CASE No. 2021-00127
RHUDES CREEK SOLAR, LLC
RESPONSES TO SITING BOARD'S FIRST REQUEST FOR INFORMATION

1. Refer to the Application, Attachment A (Two-Mile Vicinity Map).
 - a. Explain whether these neighborhoods have been identified using the definition in KRS 278.700.
 - b. Describe the number of neighborhoods identified, including the number within the two-mile radius and the number outside it.
 - c. Provide a new map (or an updated and zoomed in version of this map) that includes the following additions: 1,000-foot radius, 2,000-foot radius, one-mile radius, locations of individual homes that are not part of the identified residential neighborhoods (such as are depicted in Attachment 19 of the Site Assessment Report (SAR)), location of project substation and interconnection point, and location of proposed transmission line.

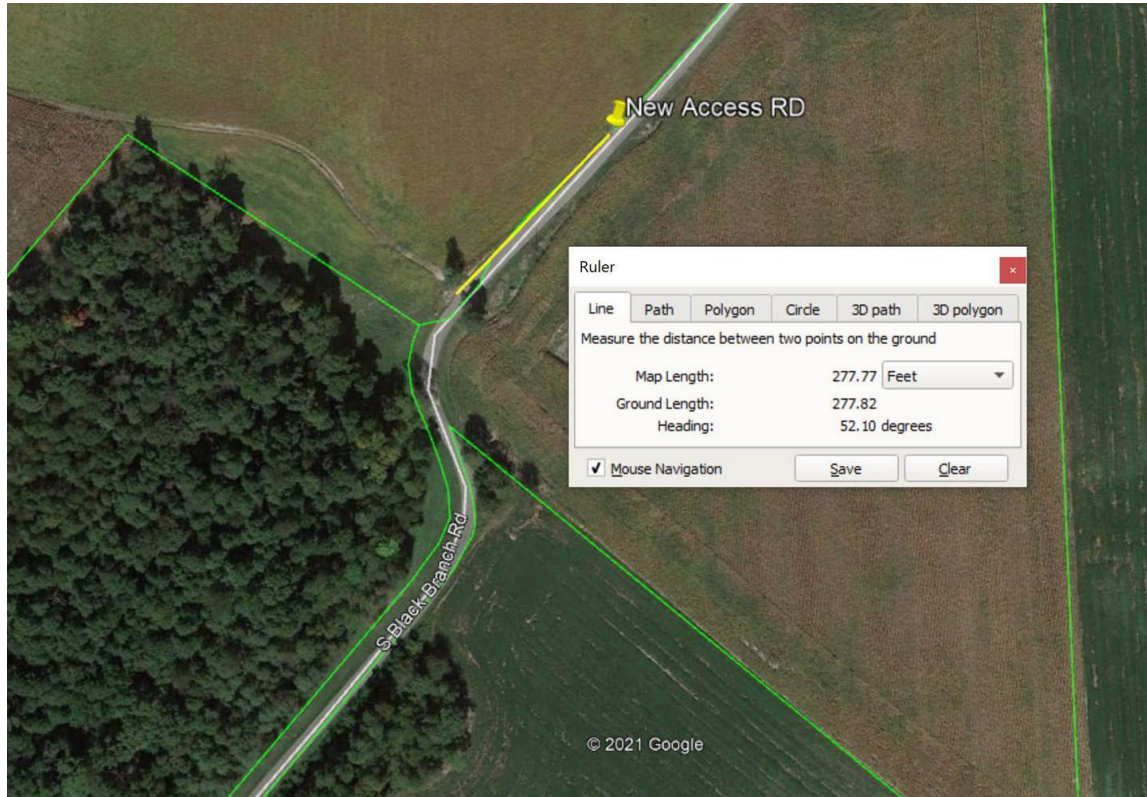
5. Describe all discussions and provide all correspondence between Rhudes Creek Solar and the Hardin County road department regarding the proposed project, traffic impacts, and heavy deliveries to site. Specify date, persons in the conversation, and substance of the conversation.

- **March 29, 2021 – ibV Energy Partners' Jeff Chang reached out to Hardin County Road Department's Dwight Morgan and Michael Steck to introduce the project and request an in-person review.**

- **April 2, 2021 – ibV Energy Partners' Jeff Chang went to the Hardin County Road Department's 501 Bacon Creek Road office in Elizabethtown to pick up flags to mark proposed driveway accesses along county road, South Black Branch Road.**

- **April 9, 2021 – ibV Energy Partners' Jeff Chang informed Hardin County Road Department's Dwight Morgan and Michael Steck that the proposed driveway accesses had been flagged for review.**

- • **April 15, 2021 – Hardin County Road Department's April Ogletree provided the County Road Department guidance document, Encroachment Permit Information.**

April 29 2021 – Following onsite review, Hardin County Road Department's Dwight Morgan informed ibV Energy Partners' Jeff Chang that two of the proposed driveway accesses did not meet sight distance requirements. Subsequently, Jeff Chang worked with TRC's site civil consulting team to reconfigure the access roads to be in compliance with site distance requirements.
